Aqueous Solutions (owner) AQS-MFG-GLASS_BURNOUT-NOZZLE_ORIENT
GLASS_BURNOUT fabrication drawing NOZZLE_ORIENT (AQS-PLAN-00
Type: fabrication drawing (GA / nozzle orientation / part sheet) Rev 3f7ab9ab Issued
Created: flow graph pipeline Approved: not approved (study)
Sheet 1 of 1 AQS-DWG-001

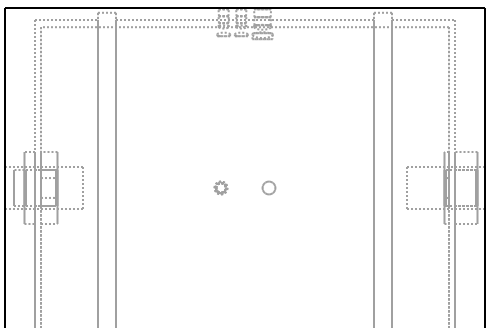
Graph revision AD - nozzle_orient: 7 schedule rows of docs-authority/nozzles/GLASS_BURNOUT.csv at tag, face and bore
Graph revision AD - nozzle_orient: N1 DN25 (milled cullet) and N2 DN15 (fuel) on -Y at z 160; N3/N4 DN15 (Q2 burnout, not Q4 - row quoting repaired) and N5
Graph revision AD - nozzle_orient: N6 drain flush at the envelope bottom (50 datum); N7 vent flush at the envelope
Graph revision AD - nozzle_orient: Atmospheric hose barbs per duty section 4; the schedule rating column (Class 1
